ADDENDUM #1
INVITATION FOR BID #22-33

POLICE HEADQUARTERS HVAC SYSTEM IMPROVEMENTS

THIS ADDENDUM IS TO: ANSWER THE QUESTIONS BELOW AND TO PROVIDE AMENDED PROJECT DRAWINGS, ATTACHED:

SECOND FLOOR PLAN
SCALE: 1/4"=1'-0"

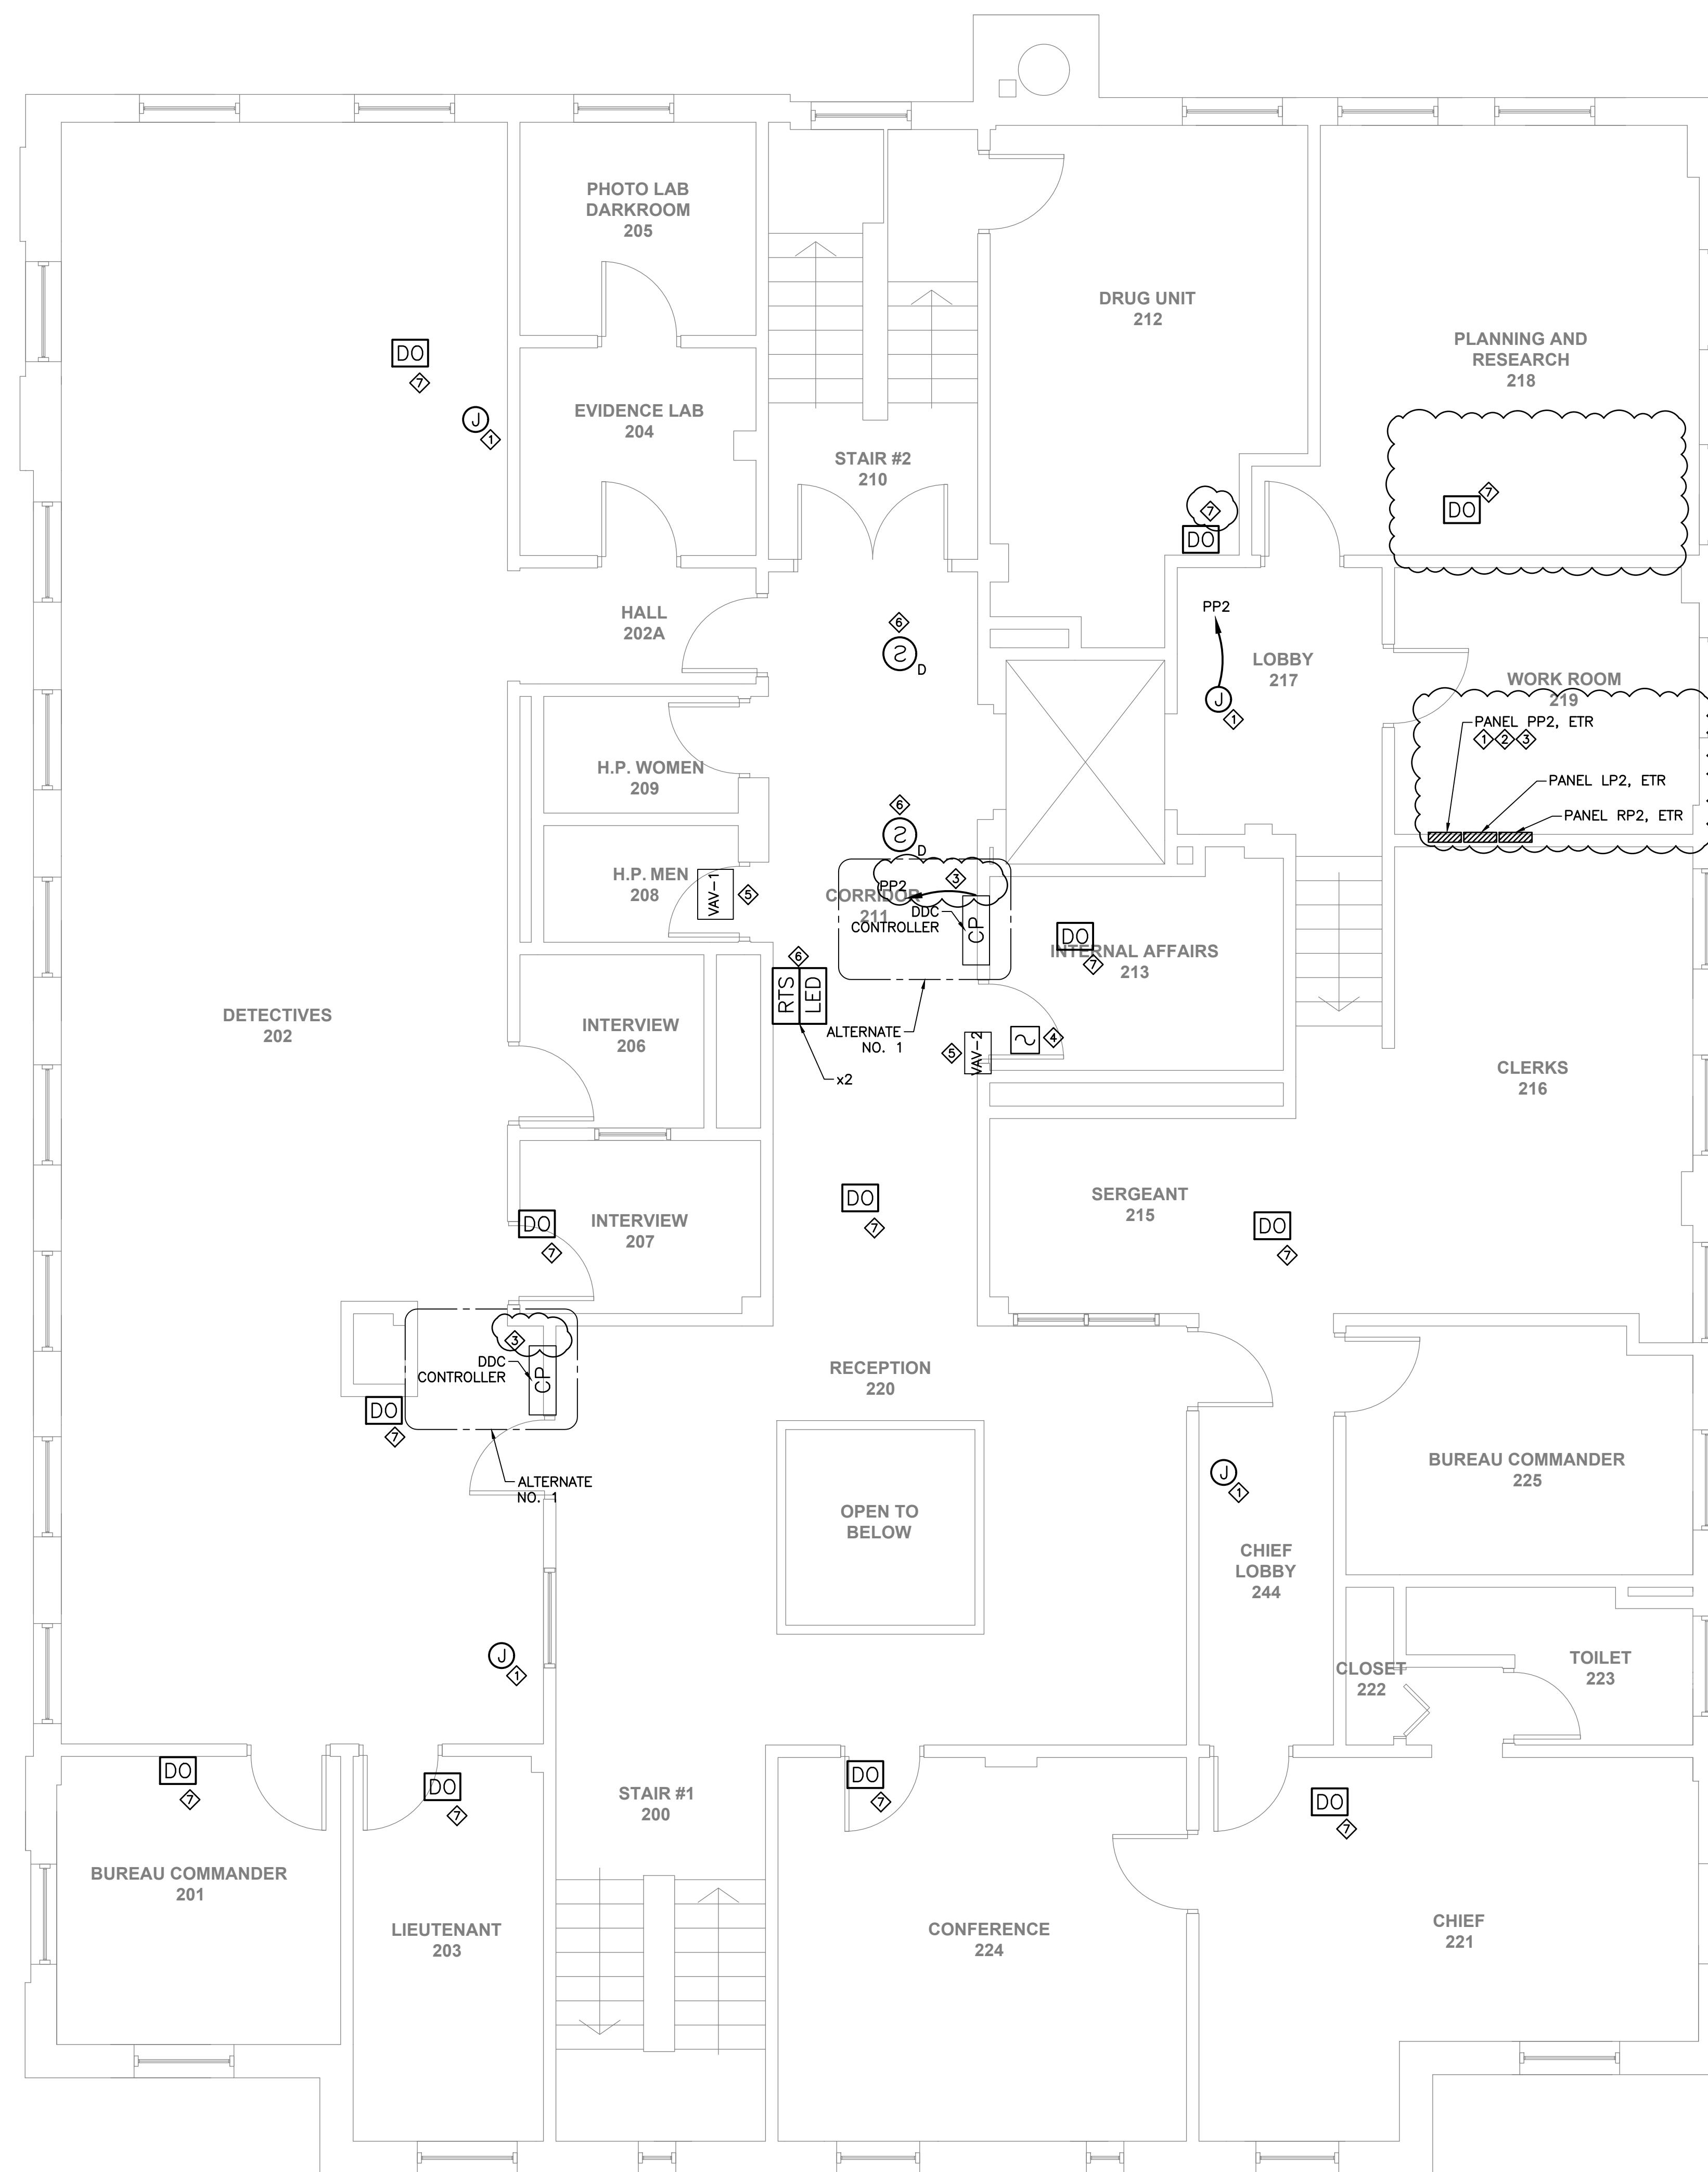
Drawing E-3: DDC Controllers are shown as hardwired now. Included the removal of three outside units for the existing heat pumps system serving Rooms 118, and 119. Panel Circuits have been added for those pieces of equipment that were thought to have been feed from the Outside Units.

1 BASEMENT HVAC NEW WORK PLAN
SCALE: 1/4" = 1'-0"

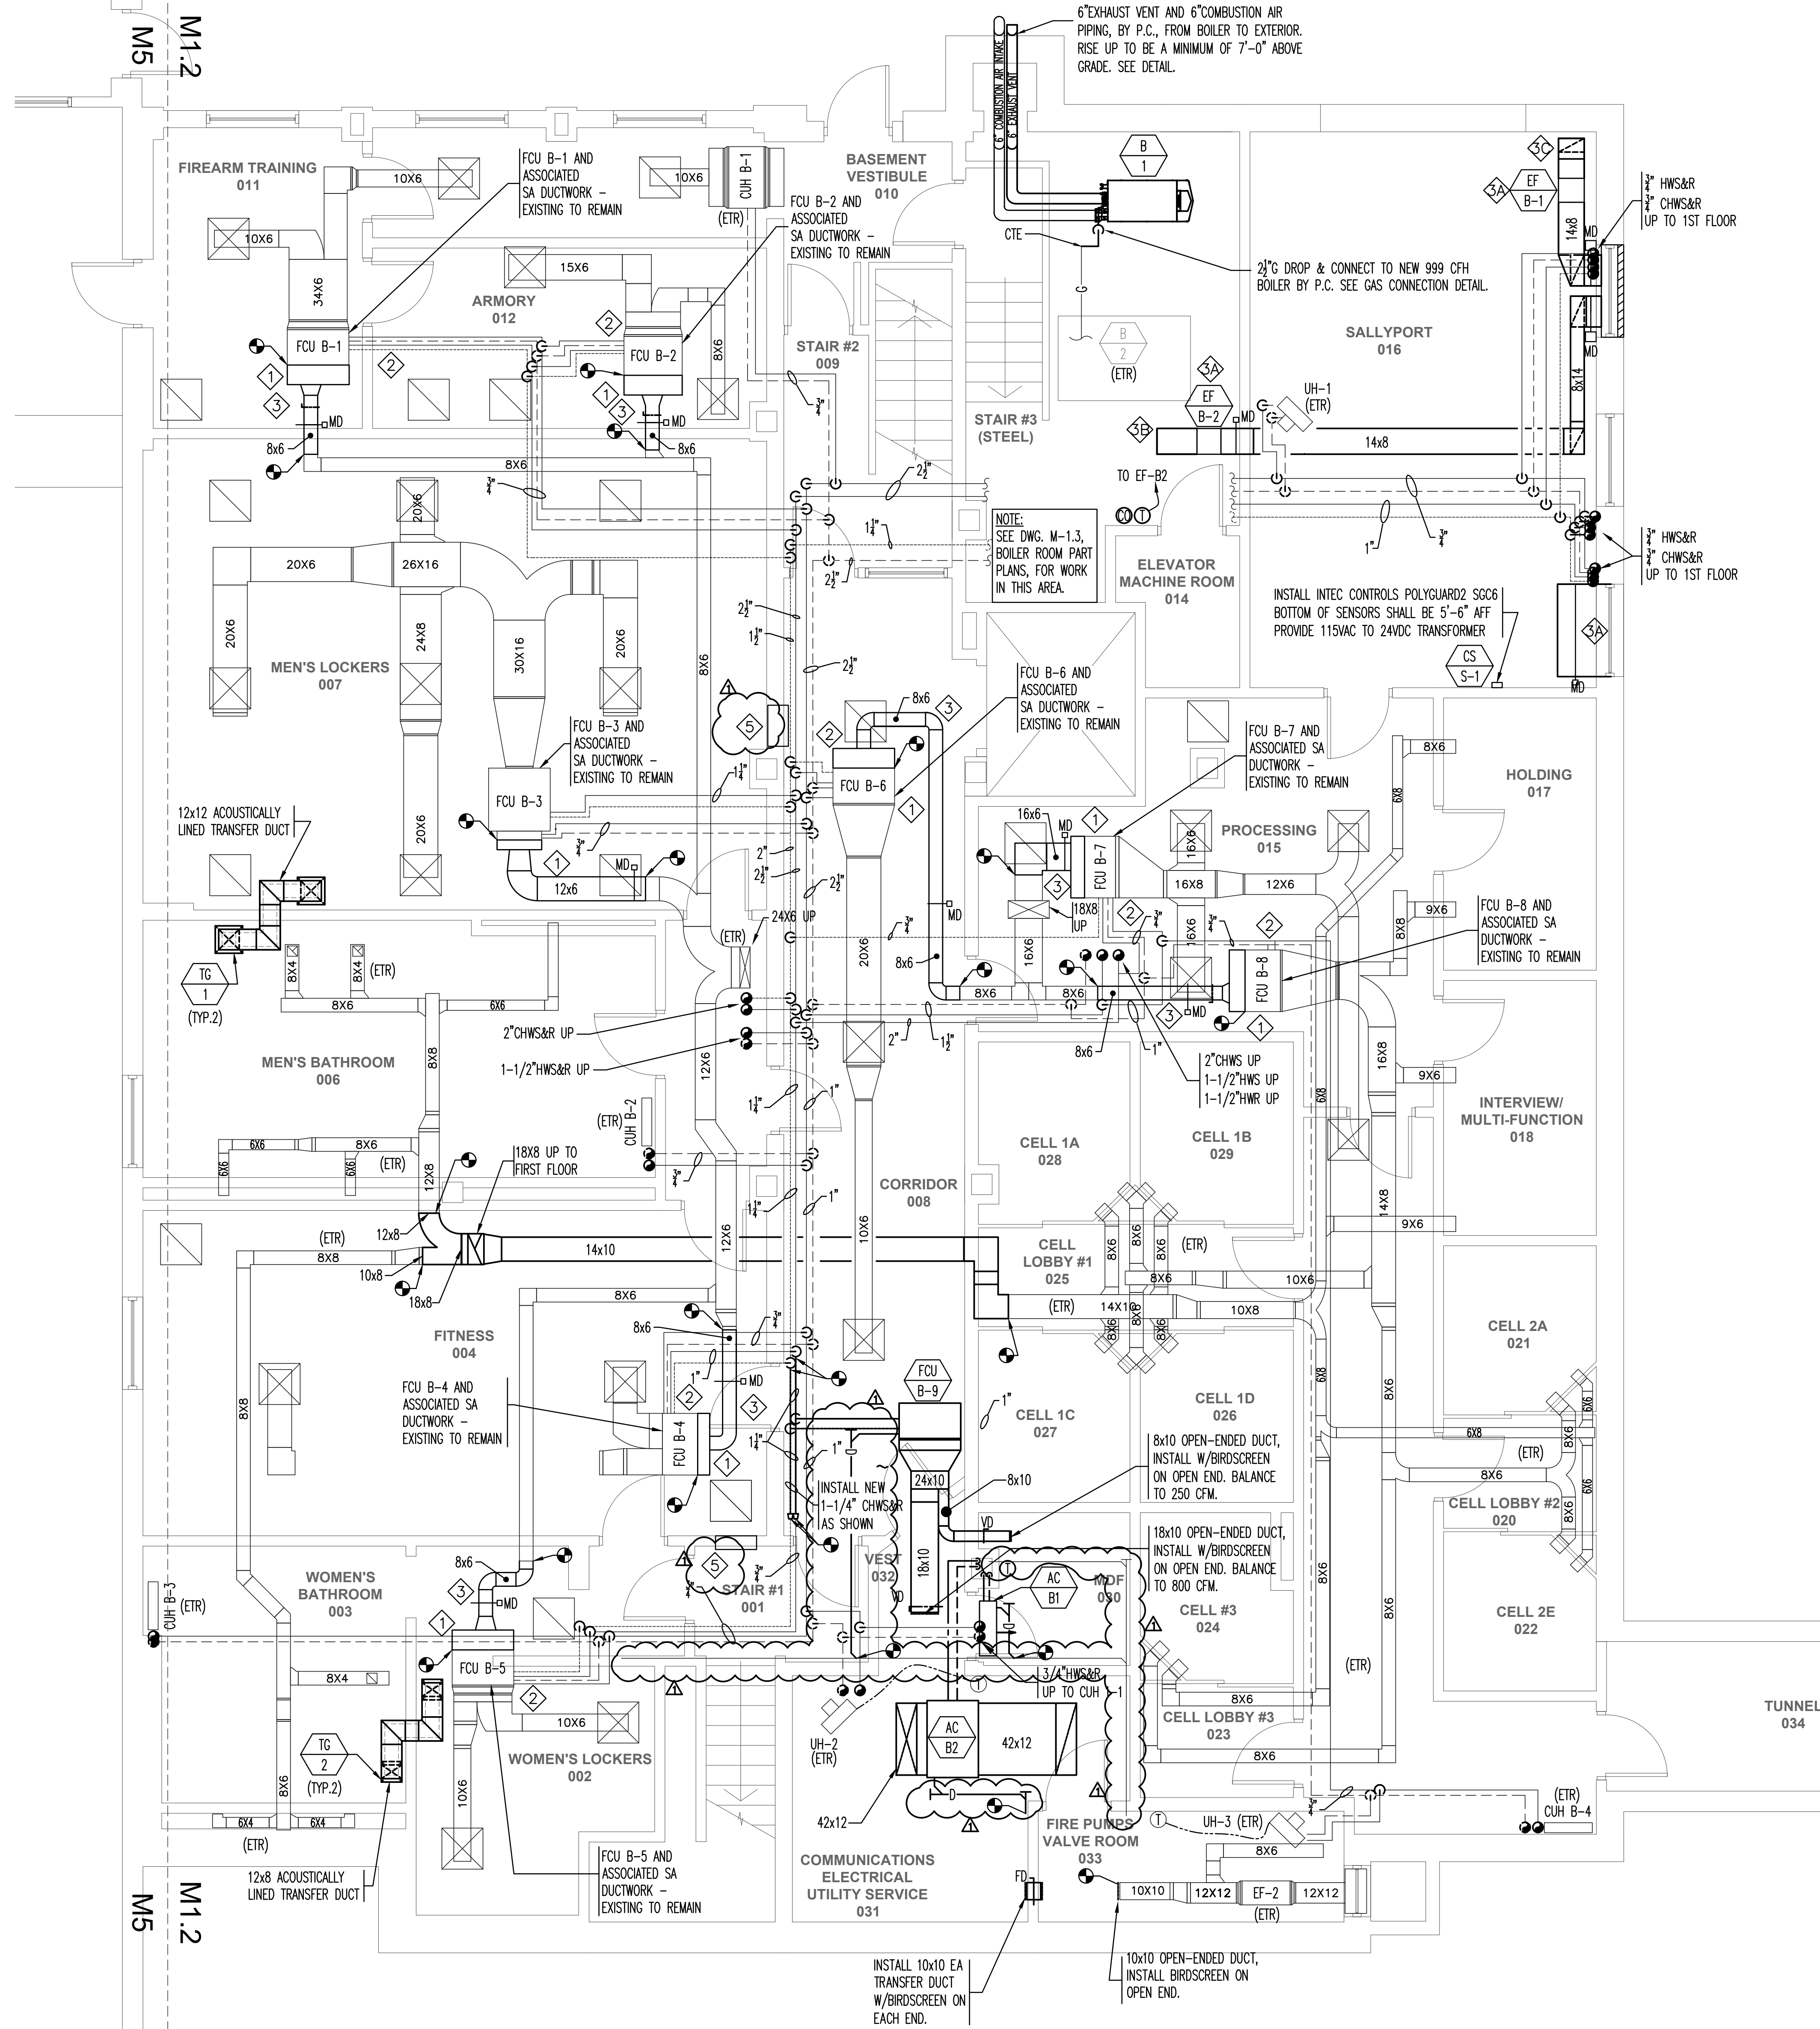
Q9. Please indicate on Drawing M-1.2 where the condensate piping for FCU-B-9, AC-B-1 and AC-B-2 is to be routed and terminated.

Drawing M-1.2: Removed the control panel addition from Alternate #1 to the Base Bid. Clarified the location of the existing condensate drain line and how the new equipment attached to it.

A9. There is an existing condensate drain that is being disconnected as part of the demo work. This drain should be re-piped as required to connect to AC-B-2.

The 1-1/4" condensate drain line comes down from the first floor into the corner of Room 030, AC-B-1 should tie into that drain line.

FCU-B-9 shall tie into the existing condensate drain piping in the corridor.

Drawing M-1.2 has been updated to show this.
